UNITED STATES PATENT AND TRADEMARK OFFICE

APPLICATION NO.	FILING DATE	FIRST NAMED INVENTOR	ATTORNEY DOCKET NO.	CONFIRMATION NO.
10/604,497	07/25/2003	Andrew Capon	70078-0179	1496

Office Action Summary

DETAILED ACTION

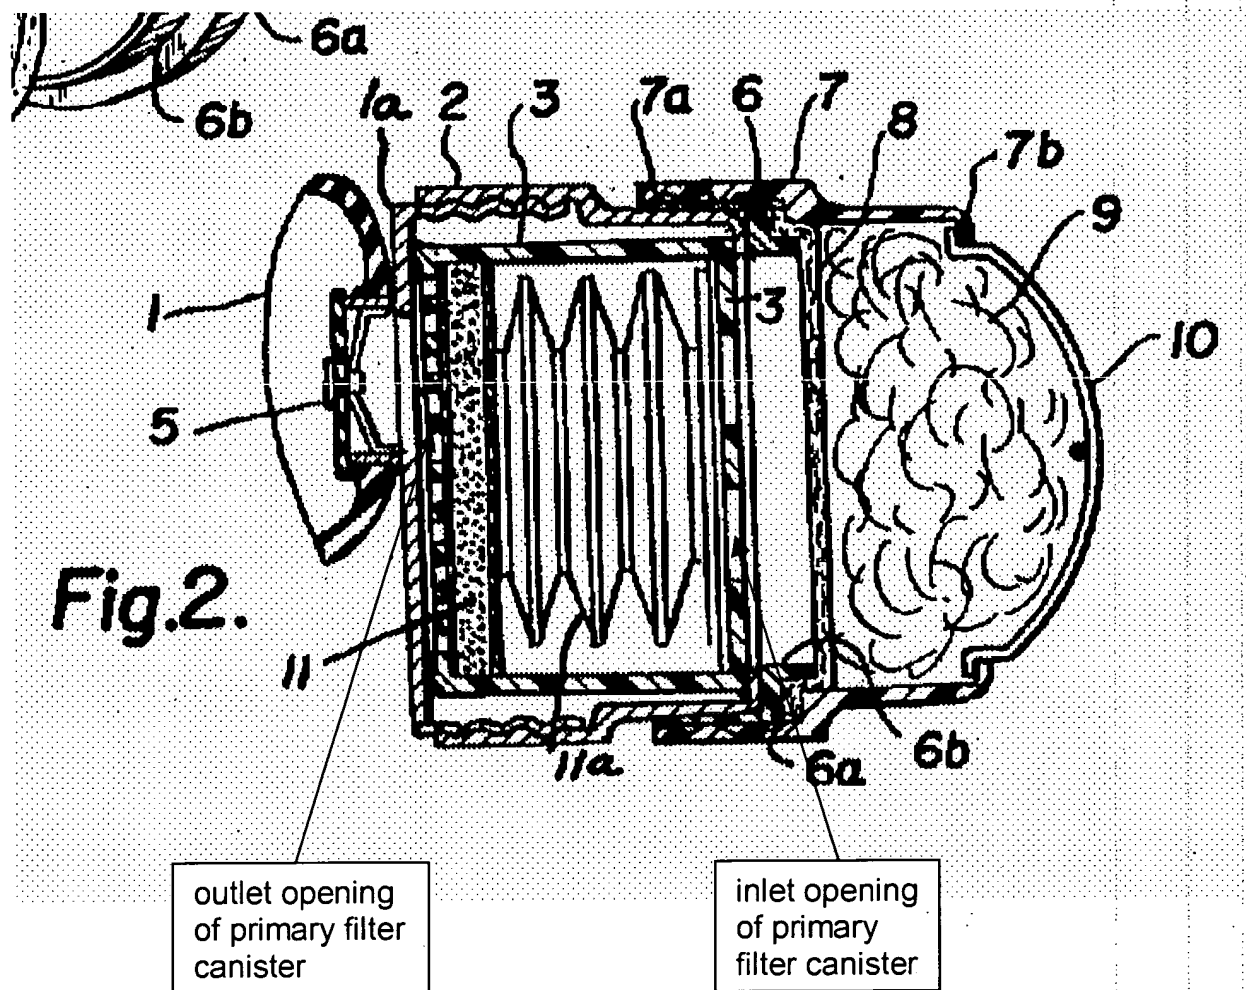
6. **As to claim 1**, Klusewitz et al teach a filter canister assembly (**See Fig. 2**) for a gas mask **1** comprising: a primary filter canister **2,3** with an inlet opening at a first end (**See Fig. 2 attachment below**) and an outlet at a second end (**See Fig. 2 attachment below**); a first filter medium **11a** adapted to remove aerosols, particulate materials and droplets from air and mounted in the primary filter canister in communication with the primary filter canister inlet opening; a second filter medium **11** adapted to remove toxic gases and arranged in serial communication with the first filter medium in the primary filter canister and with the outlet opening in the first filter housing, whereby the first filter and second filter media are capable of filtering out contaminants in normal hostile environments; and a supplementary filter canister **7** having an inlet opening (**that formed at 7b**) at a first end **7b** and an outlet opening (**that formed at 7a**) at a second end **7a**, the supplementary filter canister second end is removably (**See Figs. 1-2**) mounted to the primary filter canister first end so that the primary filter canister inlet opening is in communication with the supplementary filter canister outlet opening; and a third filter media **8,9** adapted to filter toxic industrial materials and mounted in said supplementary filter canister in communication with the inlet and outlet openings in the second filter canister.
